Massachusetts College of Art and Design

ADA Compliance Plan 2011

ADA Compliance Plan
Consultant Services
Contract #10-08

The Institute for Human Centered Design

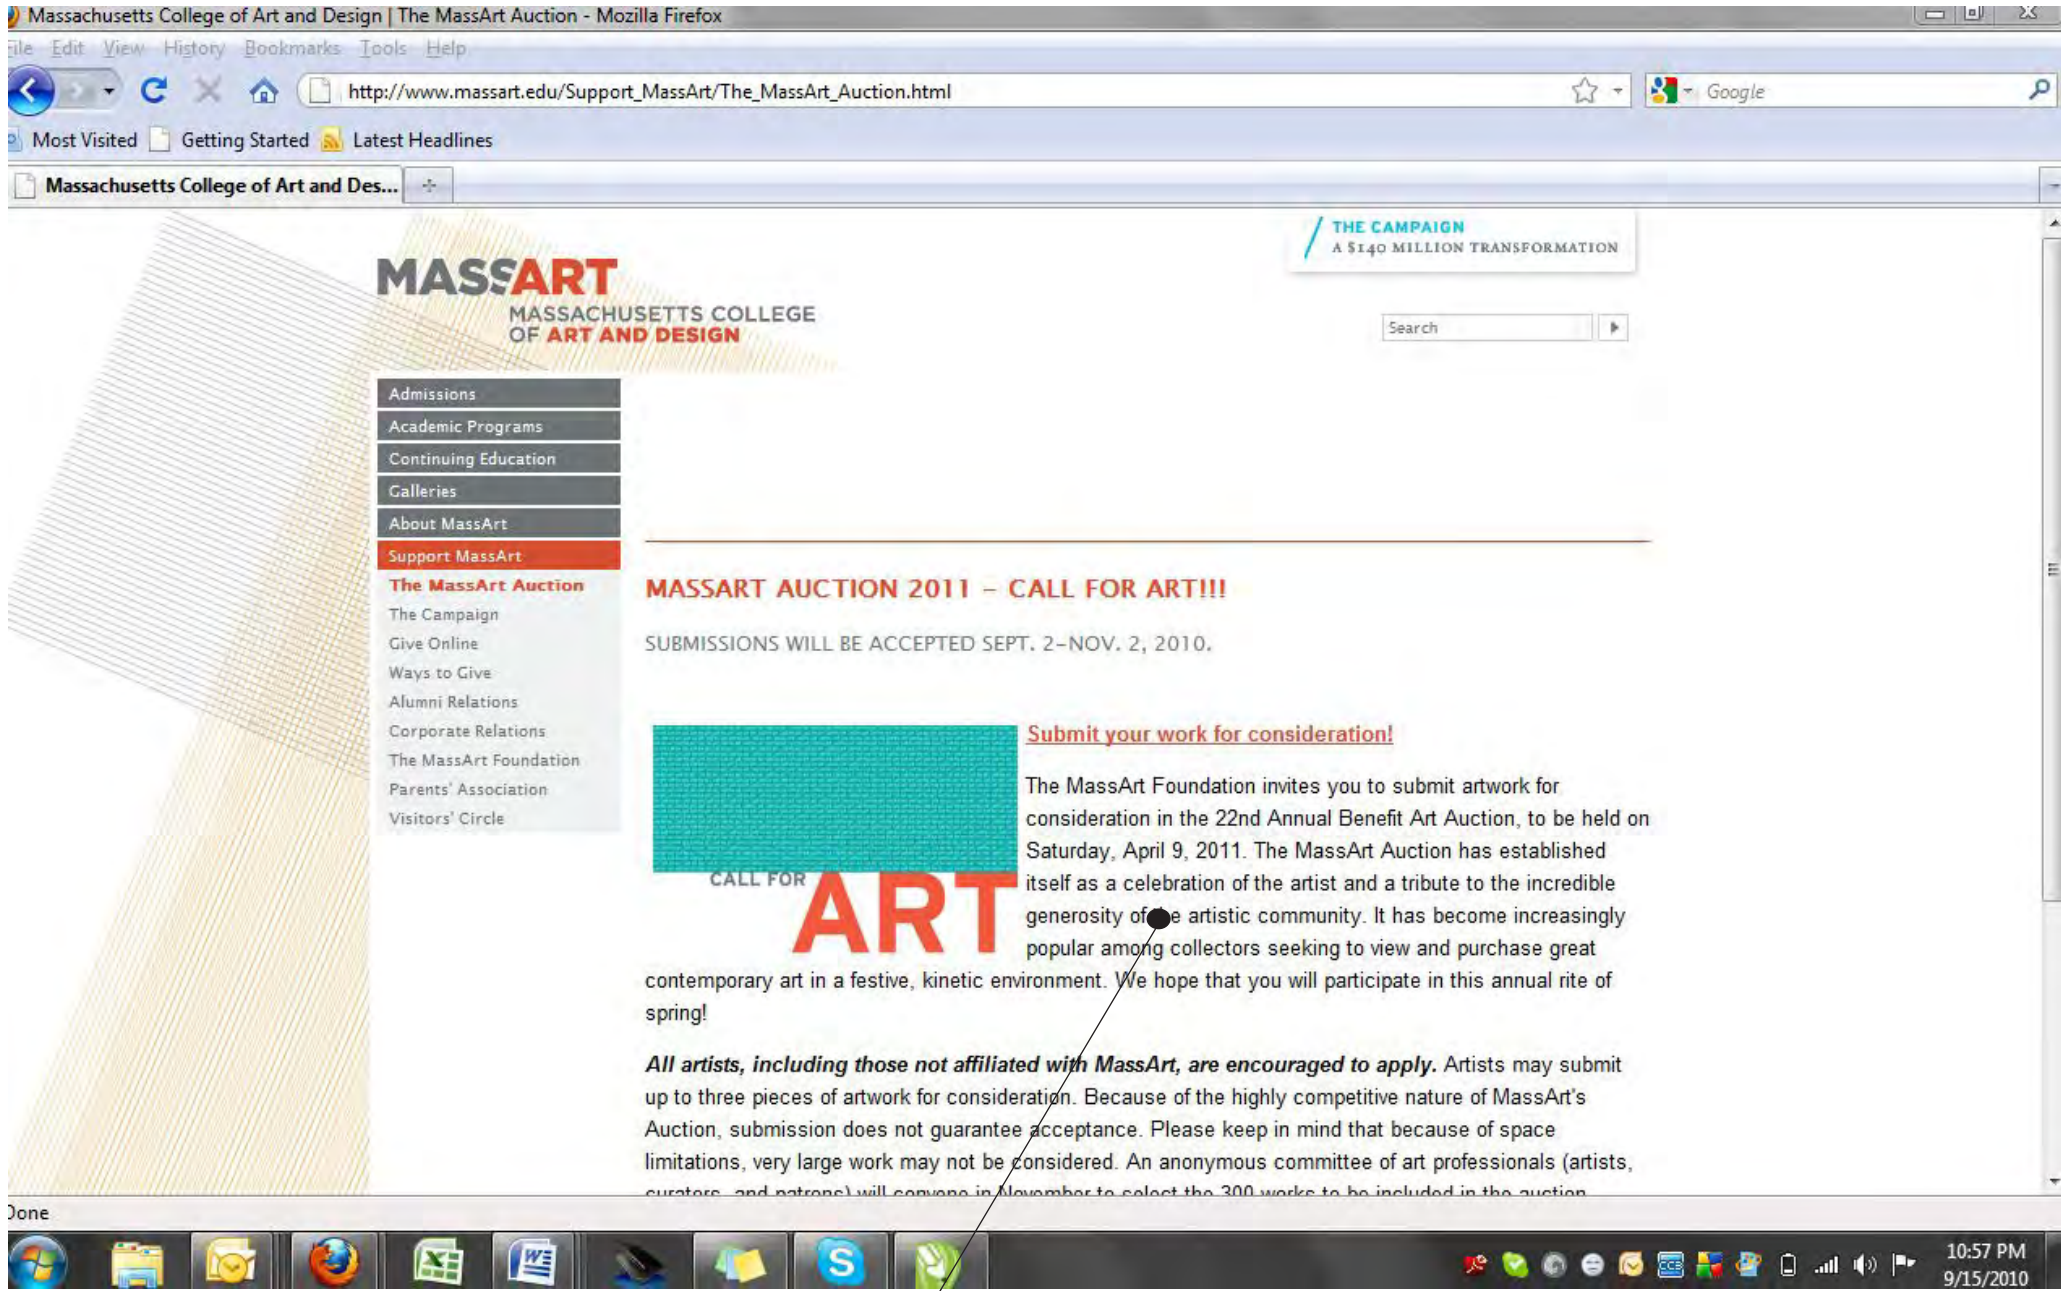
Nice use of color headings for sections.

Increasing the font size slightly and or increasing the contrast would make this text more legible. The underlines also make it more difficult to read however they remind the reader that they are links.
